October 17,2025

Notice for change to Laser Marking for POSCAP

September 29,2026

Notice of Additional Applicable Part Numbers for Change to Laser Marking for POSCAP

■ **Comparison table**

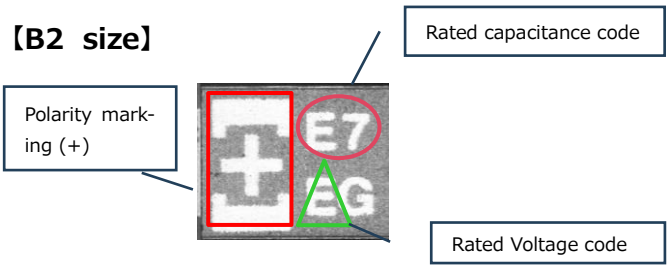
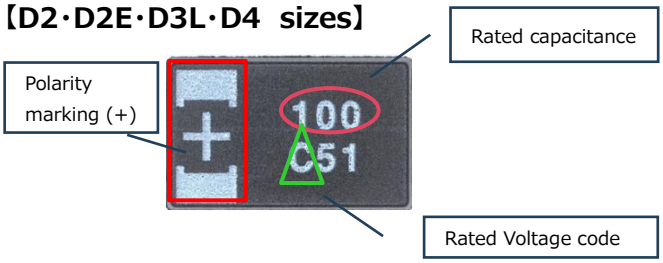
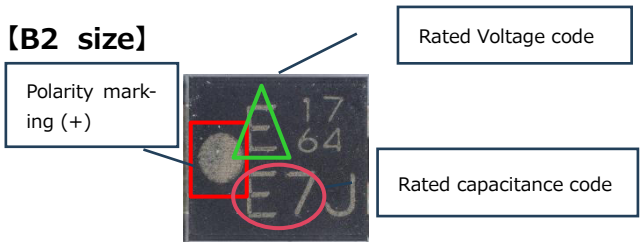
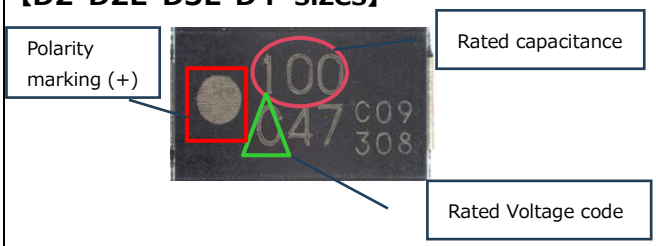
・The product marking method will be changed from UV ink to laser marking.
・The change will be implemented via a running change
Please refer to the table below for details of the marking changes.

Current Specification	After Change
UV ink marking display	Laser marking display
Marking examples for each size **【B2 size】**  **【D2･D2E･D3L･D4 sizes】**  	Marking examples for each size **【B2 size】**  **【D2･D2E･D3L･D4 sizes】** 
Traceability Only the production month can be specifically identified.	**Traceability** It is possible to narrow down by production lot.
The change is limited to the stamping specifications, and there will be no impact on product characteristics or durability.

■ **Comparison table**

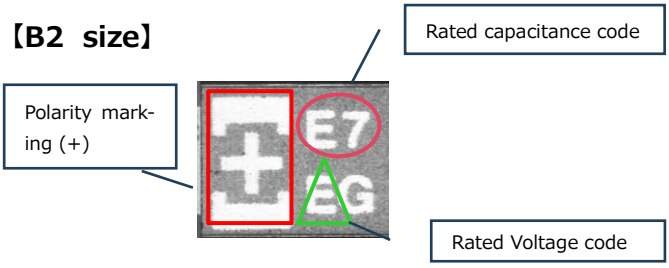
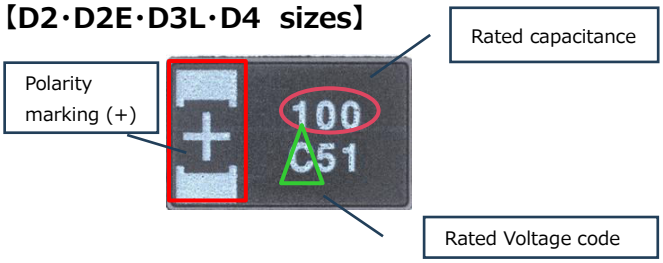
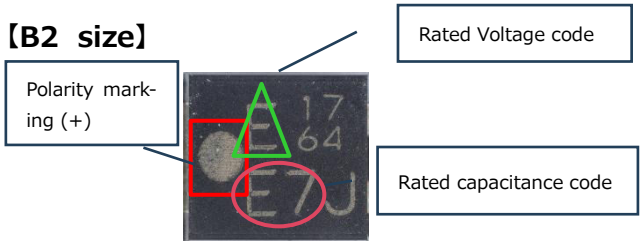
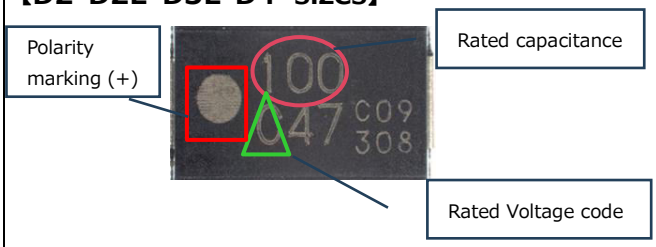
・The product marking method will be changed from UV ink to laser marking.
・The change will be implemented via a running change
Please refer to the table below for details of the marking changes.

Current Specification	After Change
UV ink marking display	Laser marking display
Marking examples for each size **【B2 size】**  **【D2･D2E･D3L･D4 sizes】**  	Marking examples for each size **【B2 size】**  **【D2･D2E･D3L･D4 sizes】** 
Traceability Only the production month can be specifically identified.	**Traceability** It is possible to narrow down by production lot.
The change is limited to the stamping specifications, and there will be no impact on product characteristics or durability.
